In re Application of:  
James S. McClain  
For: ANTI-THEFT DEVICE FOR BIG  
GAME SURVEILLANCE CAMERA  
Application no: 10/679,769  
Filed: 10/06/2003  
Docket no: McClain 3  
GAU: 2622  
Examiner: Cutler, Albert H.

## AMENDMENT UNDER 37 CFR 1.111

Fig. 2

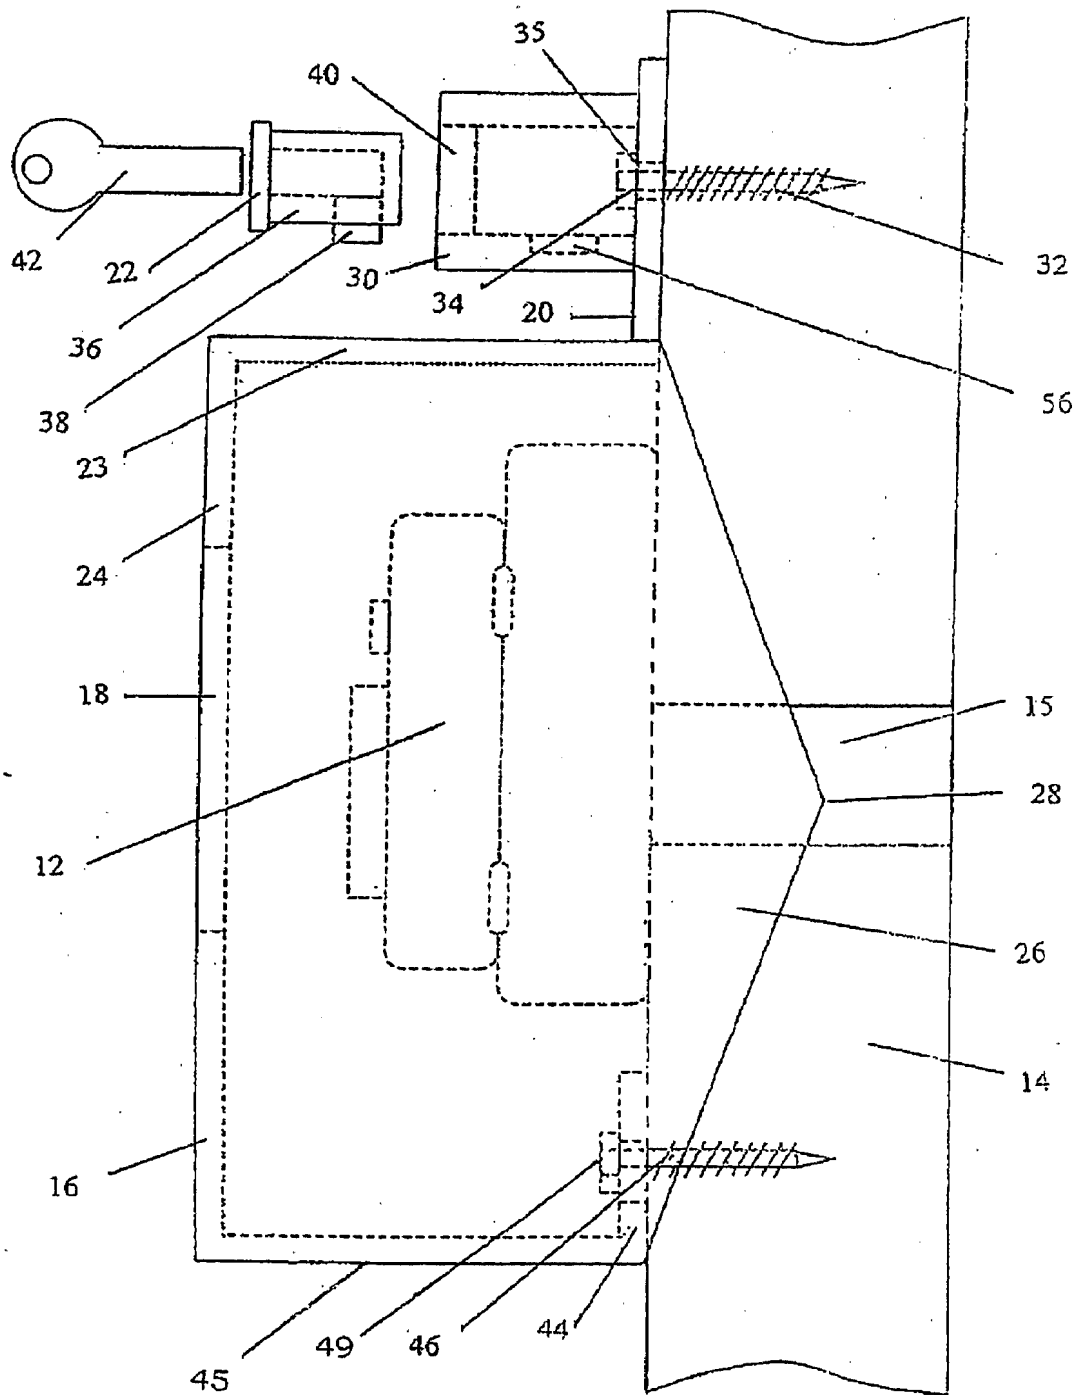
The corrections to Fig. 2 are made on the replacement sheet of drawing of Fig. 2 as required by the Examiner. Here, "bottom 45" and "head 49 of the lag bolt" are respectively labeled.
